Town of Medway  
**DESIGN REVIEW COMMITTEE**  
155 Village Street, Medway MA 02053  
(508) 533-3291

**DRC Meeting Minutes: September 09, 2019**  
Medway Public Library

**Design Review- William Wallace Village multi-family development special permit and site plan (2740-276 Village St.)**

# Road Entry Triplex

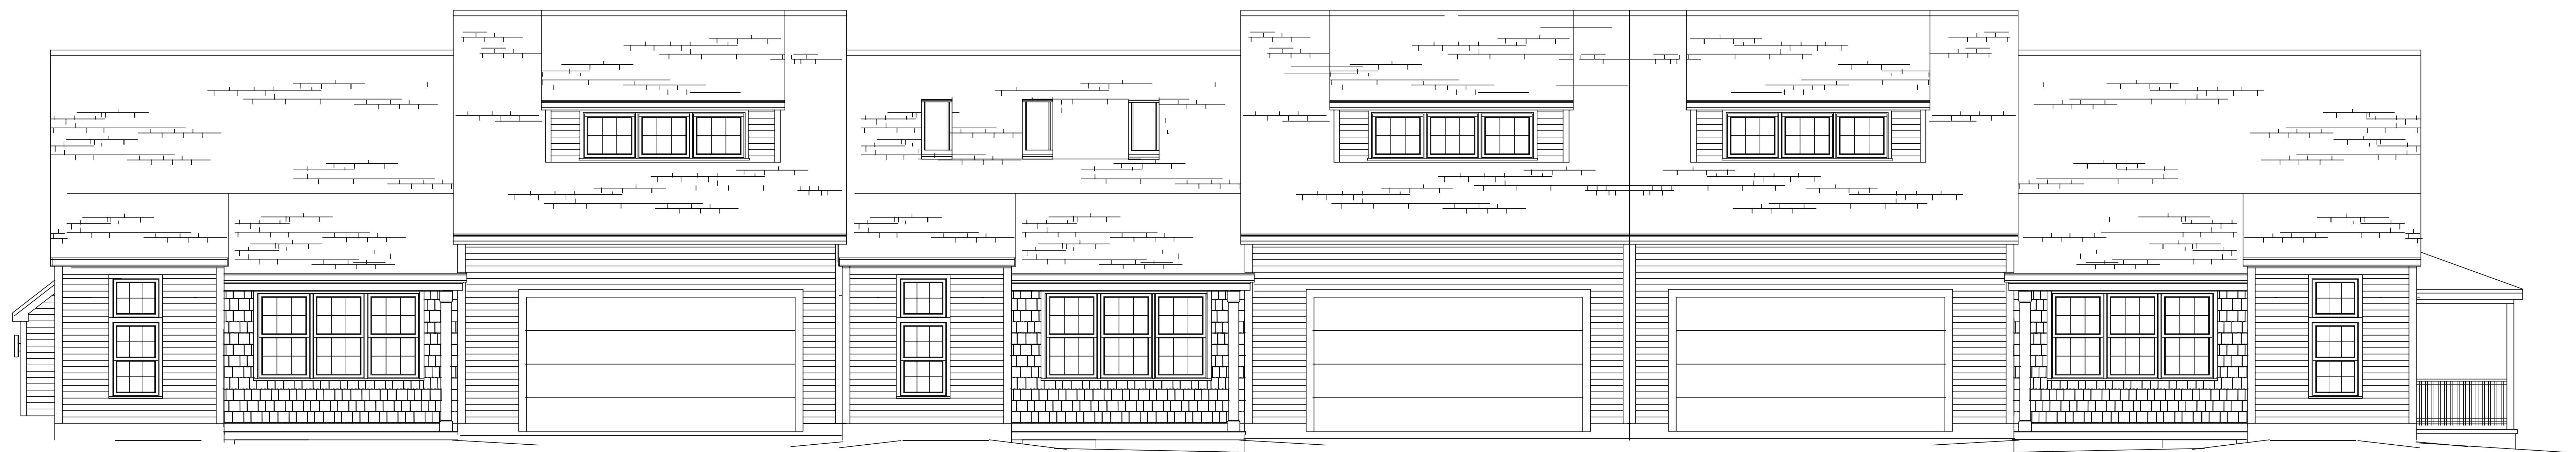
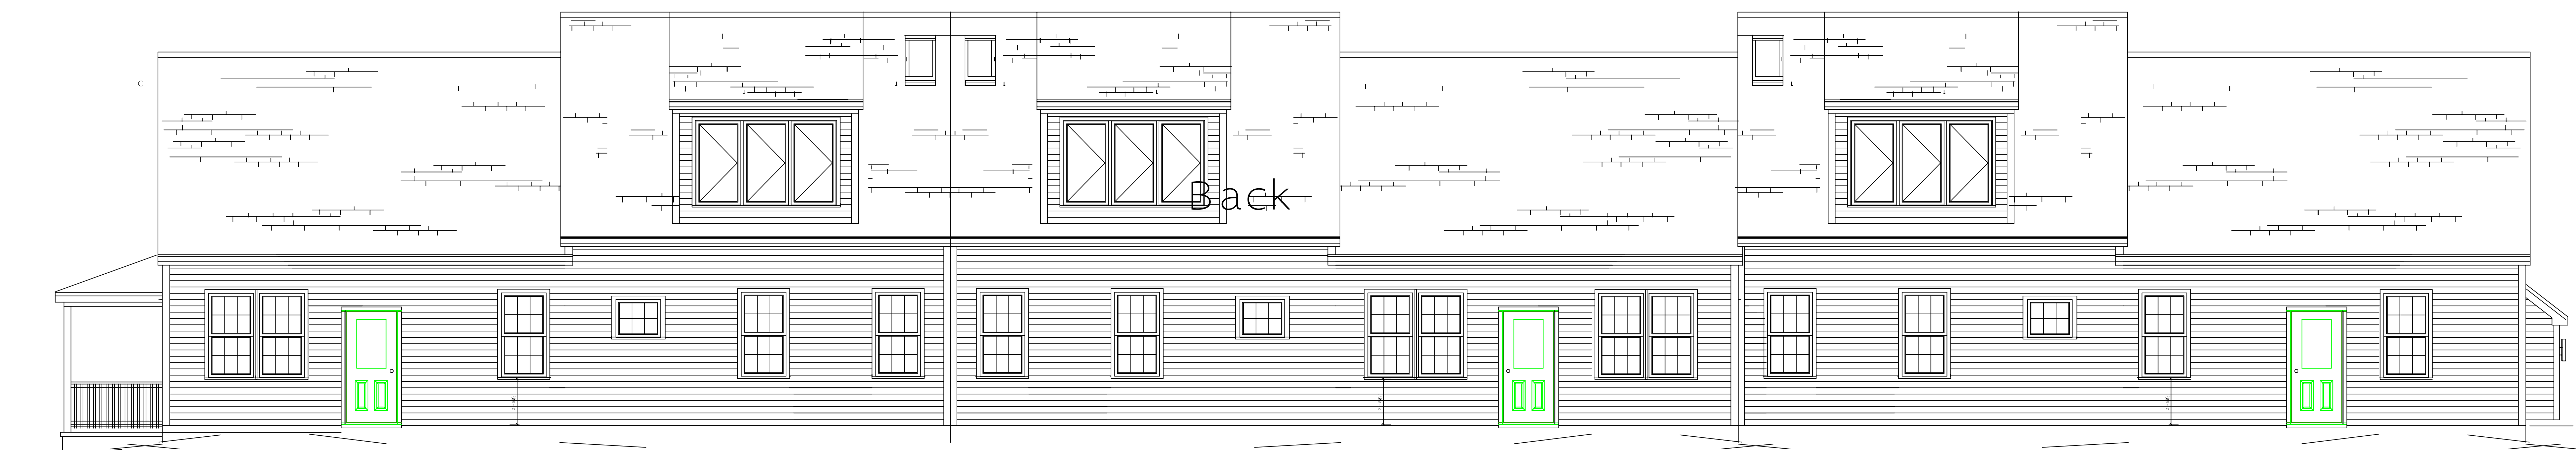
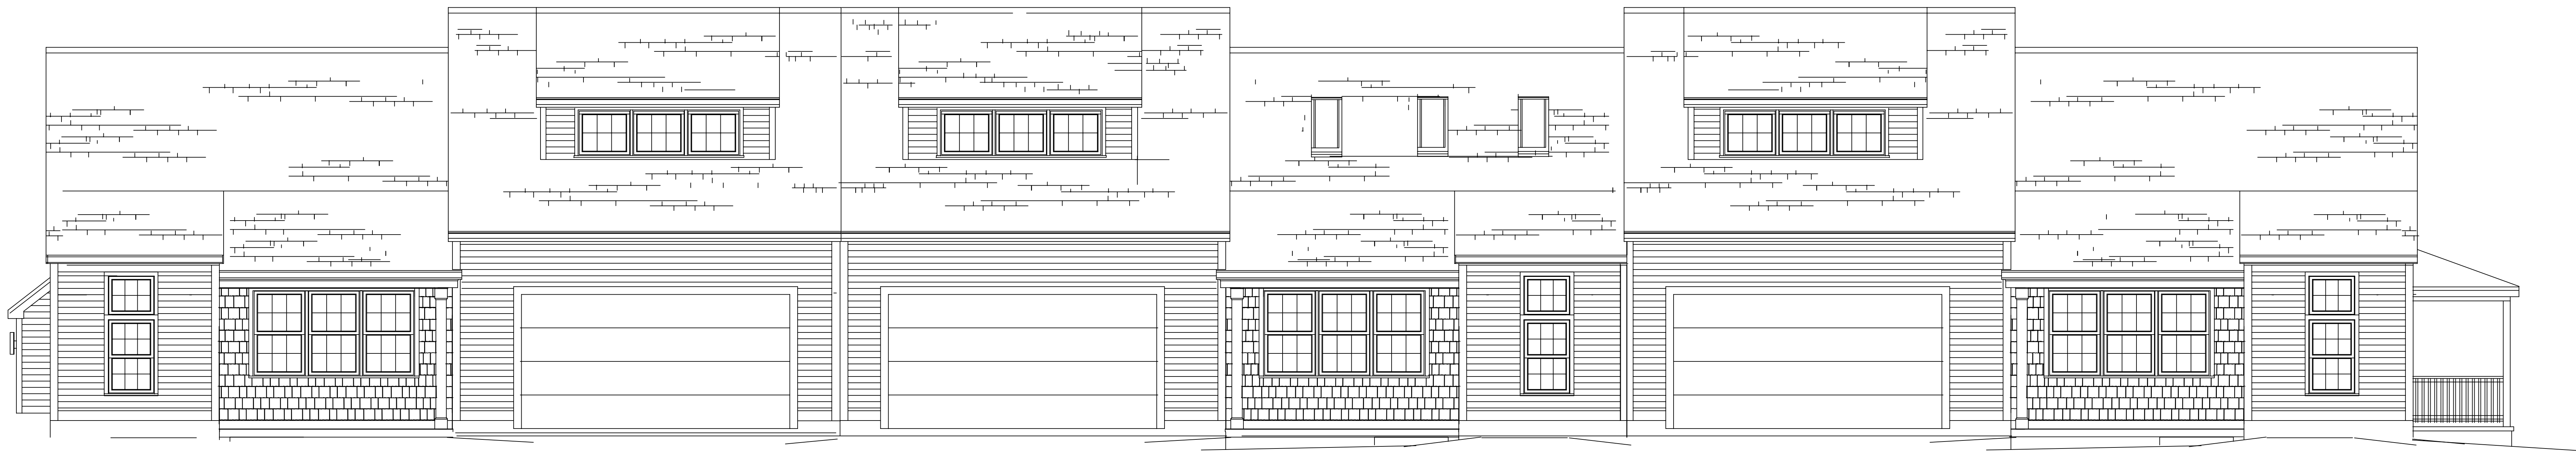
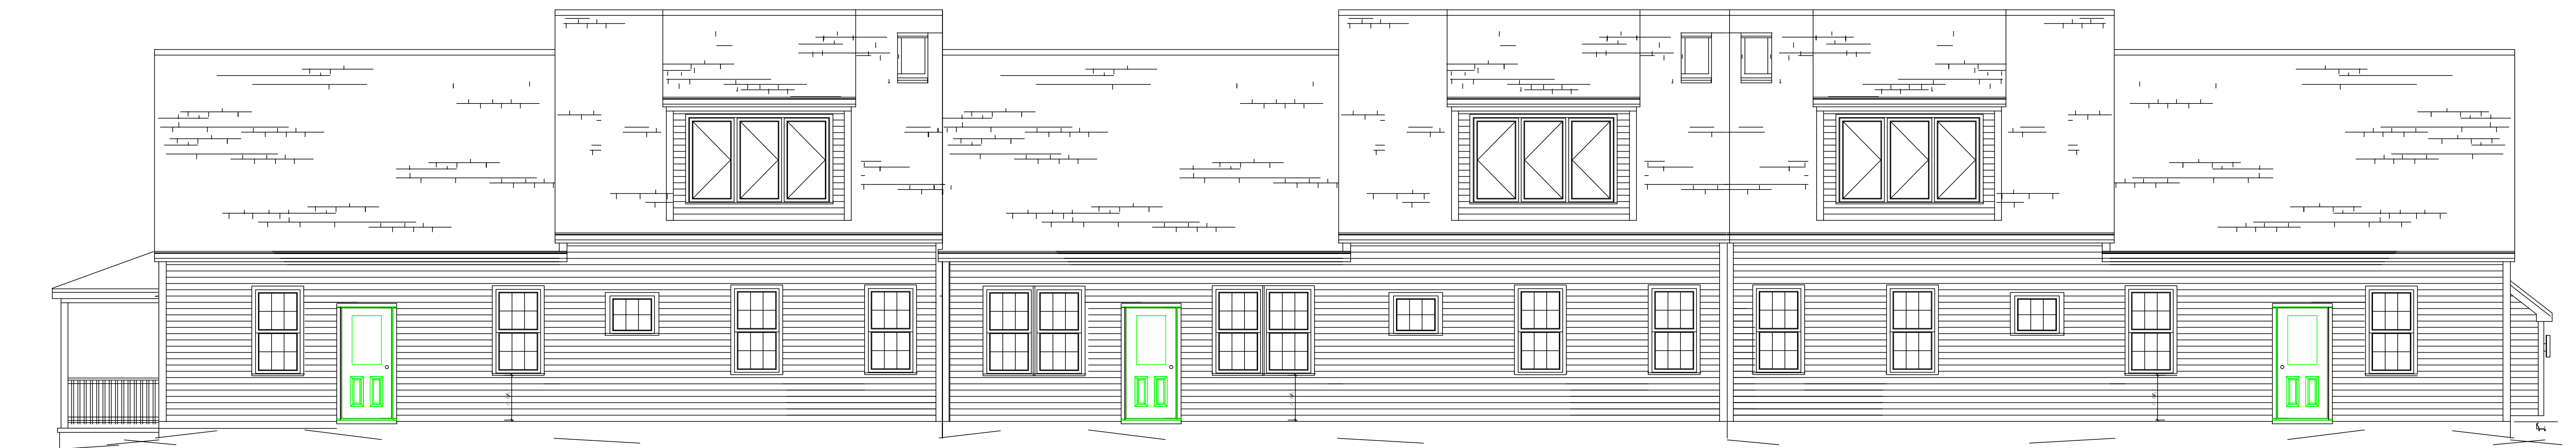
- Ms. Chabot commented on the elevation of the end (south facing) unit in the triplex building. The shingles in the gable need to extend a bit further than what's shown on the plan. Members commented the design should show a more developed porch and the feature at the end of the gable should be extended. A bay window was discussed as an option. Mr. Rucki indicated it was not structurally feasible to do so. He also said the height of the buildings is around 26 ft.

First Floor Plan  
Quadplex

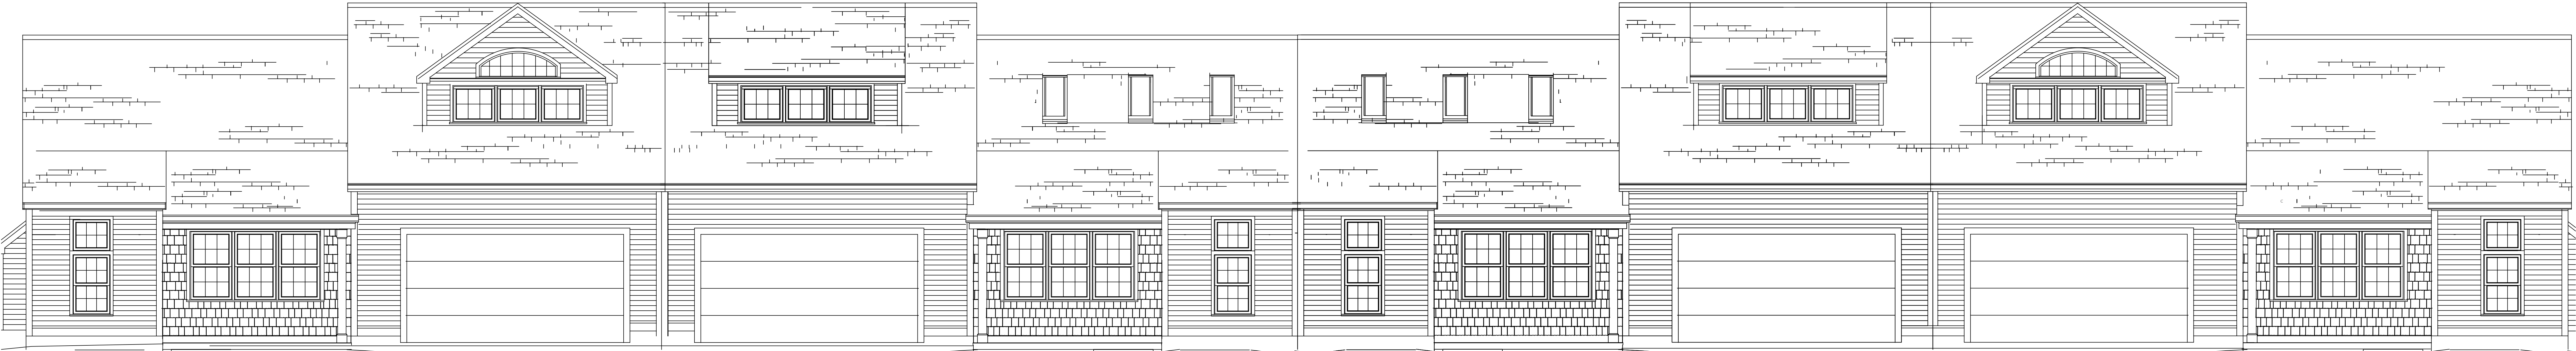
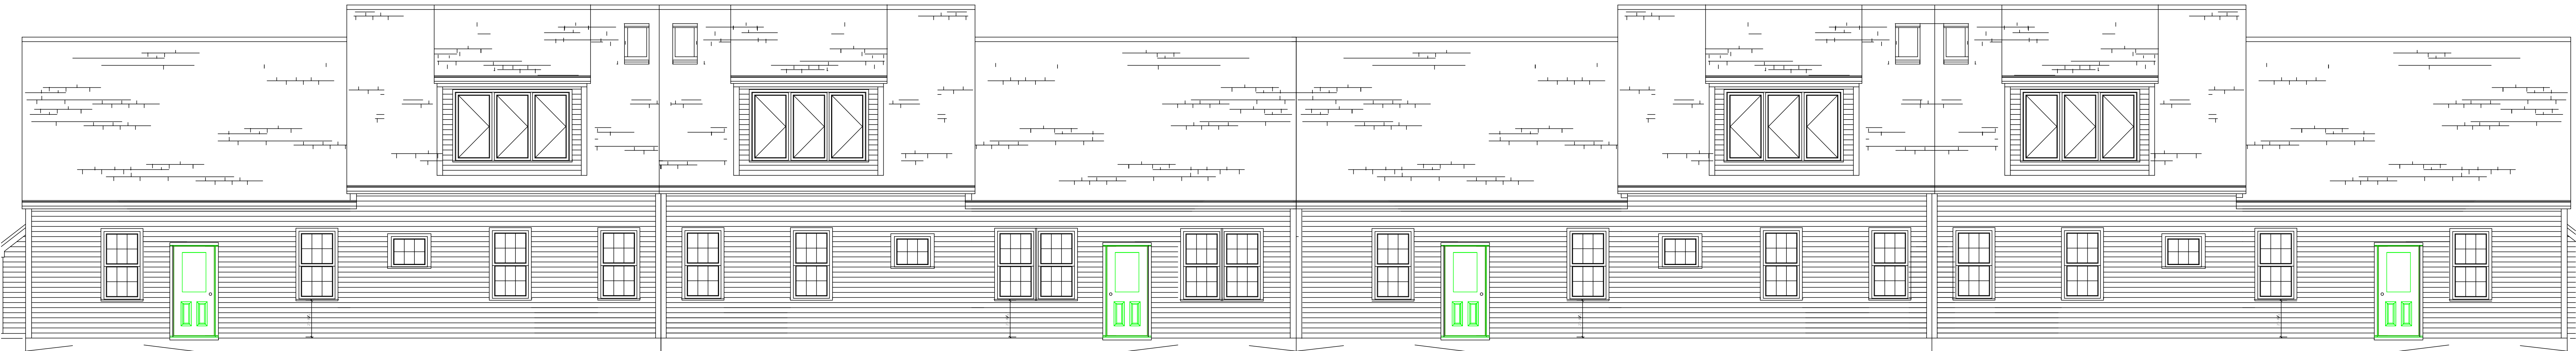
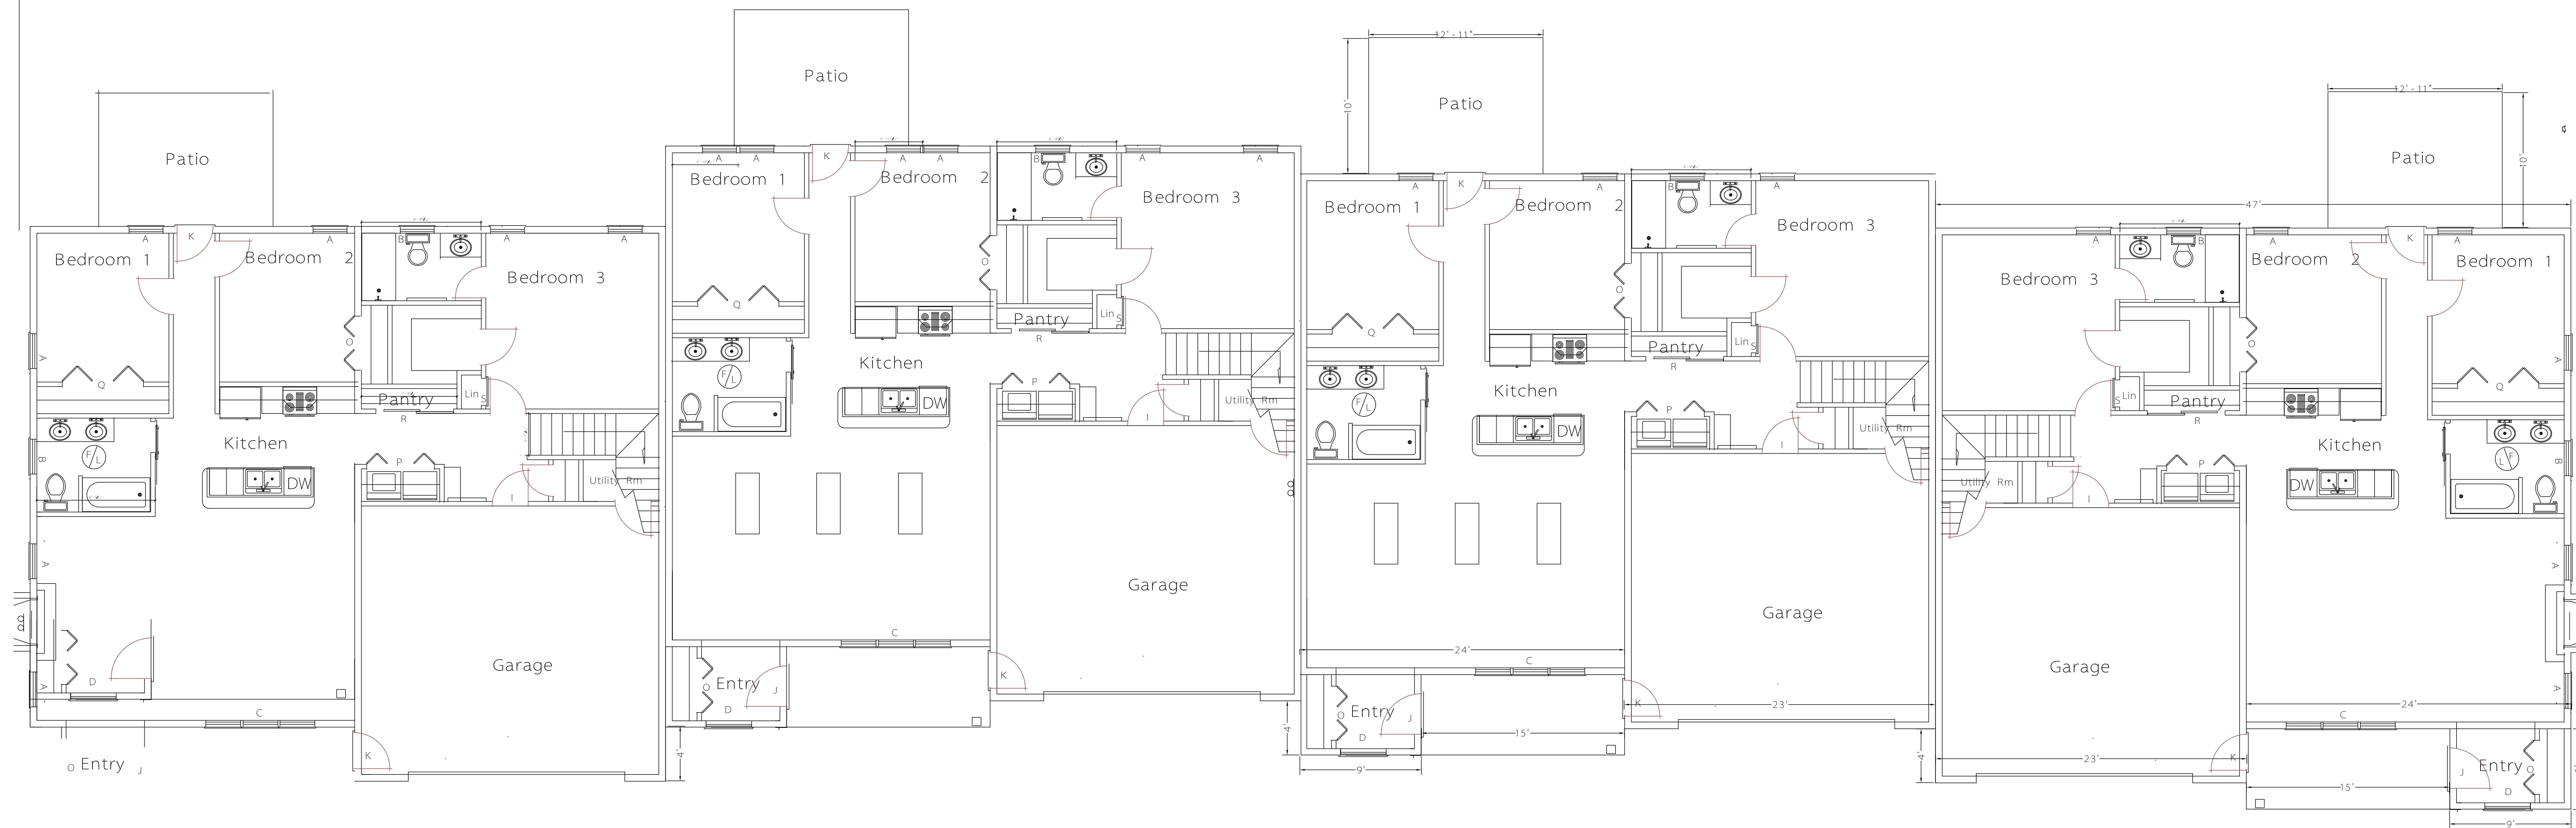
- Gable dormers were recommended by the members for the quad building instead of the mixture of gable and sheds.
- Members commented on the discrepancies between the floor plans and façade plans
